FW: DC/25/99373 Hatts Copse Farm, Botley - landscape comments

Landscape Masterplan

Landscape Plan 1 of 2

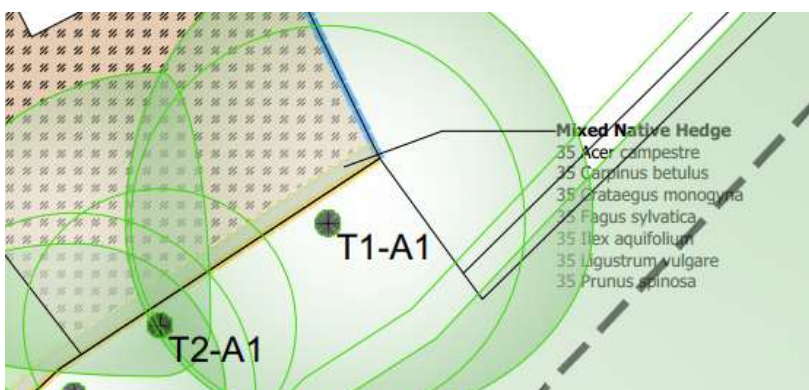
d/ Please make this symbol for the section of hedge clearer:

Can we have written assurances this can be delivered as it abuts a driveway and appears to be in a very narrow strip (i.e. is there sufficient soil rooting area for the hedge?). A site photo of the planting strip would help.
